Submission to the CNSC by the
Canadian Coalition for Nuclear Responsibility

Regarding the Darlington New Nuclear Project (DNNP)
and the documents provided in support of
siting one of four BWRX-300 reactors
at the existing Darlington NGS site

EIS Environmental Impact Statement
PPE Plant Parameter Envelope

Submitted March 20 2023

FIGURE 2.2 Iodine-131 releases from (A) BWRs and (B) PWRs in 2008. SOURCE: Daugherty and Conatser (2008).

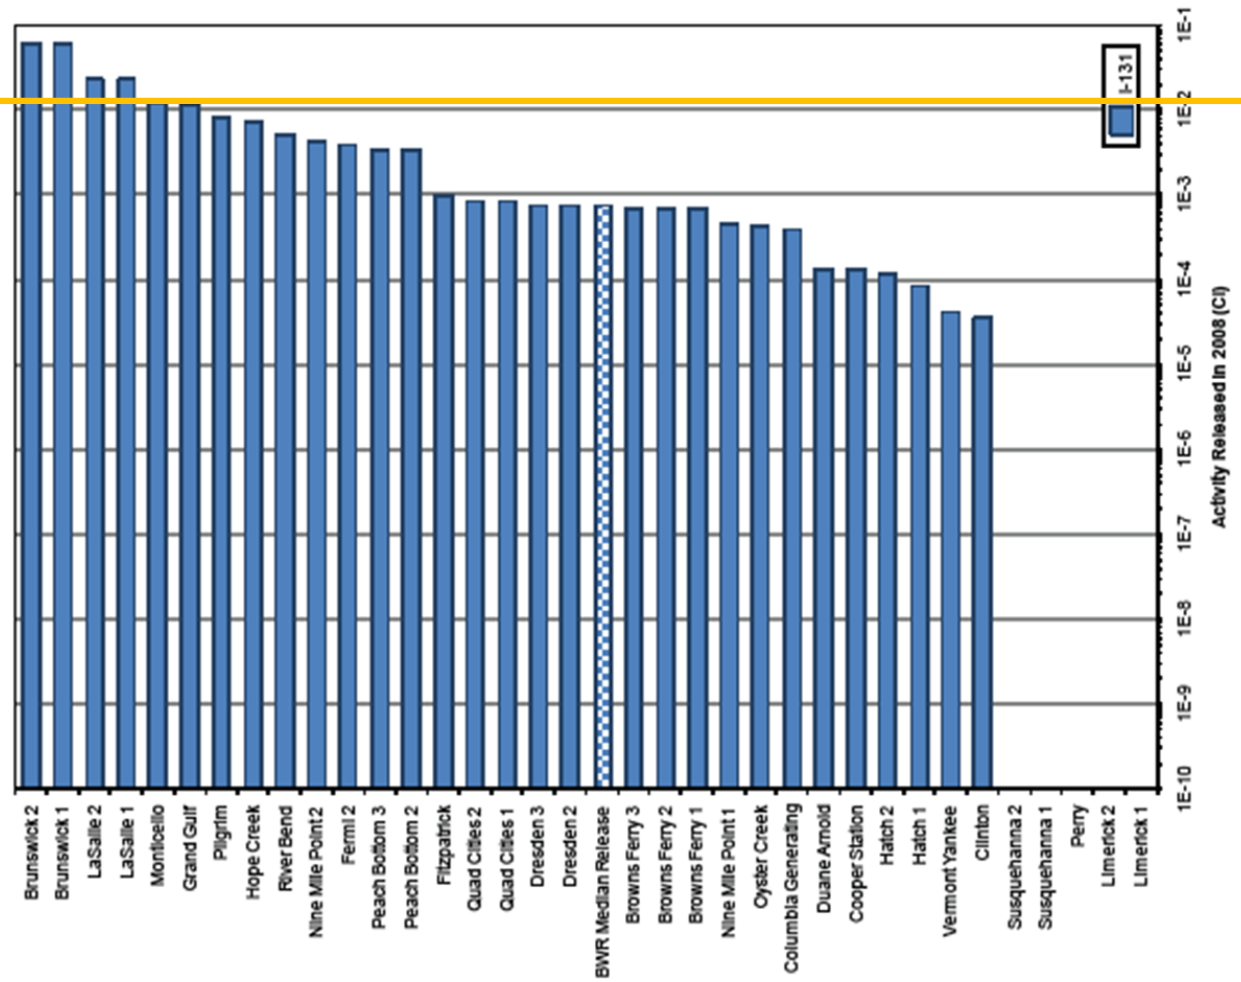
Iodine -131
 BWRX-300
 1.08×10^{-2} Ci
 =600 Sv

FIGURE 2.3 Particulate releases from (A) BWRs and (B) PWRs in 2008. SOURCE: Daugherty and Conatser (2008).

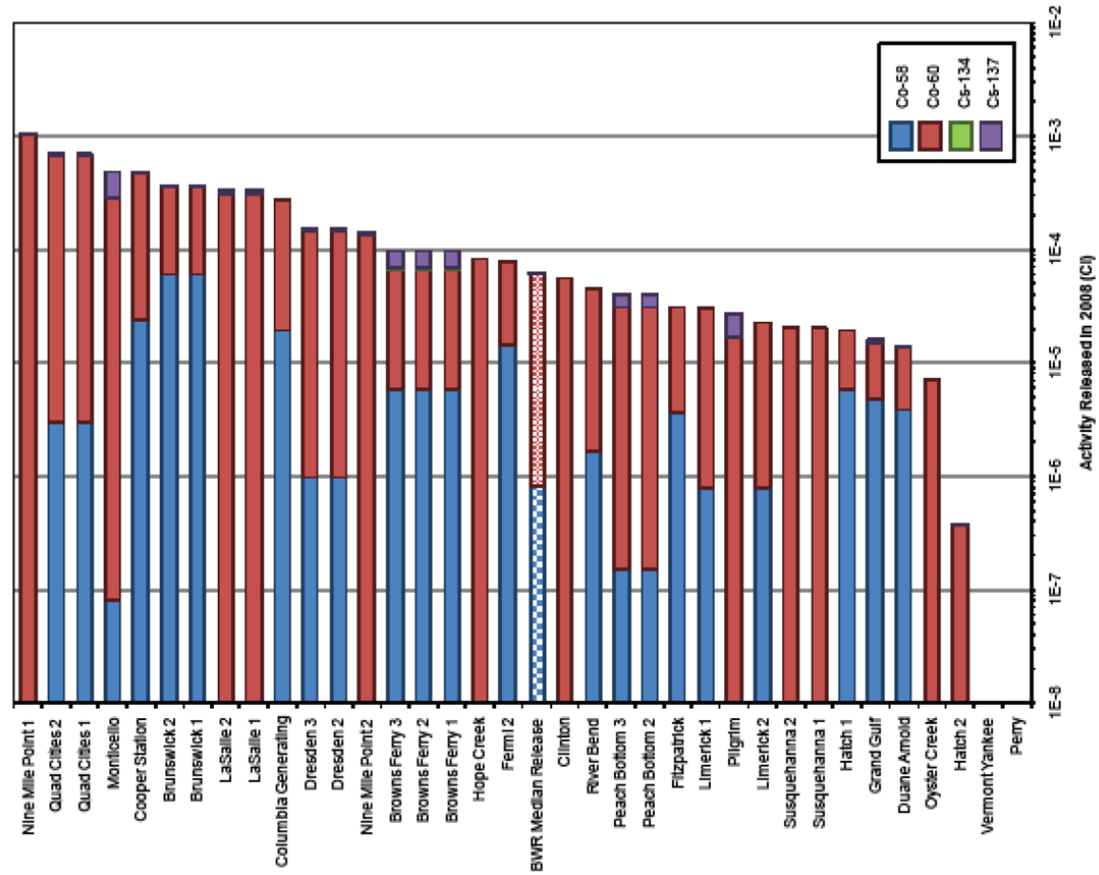
BWRX-300 no data
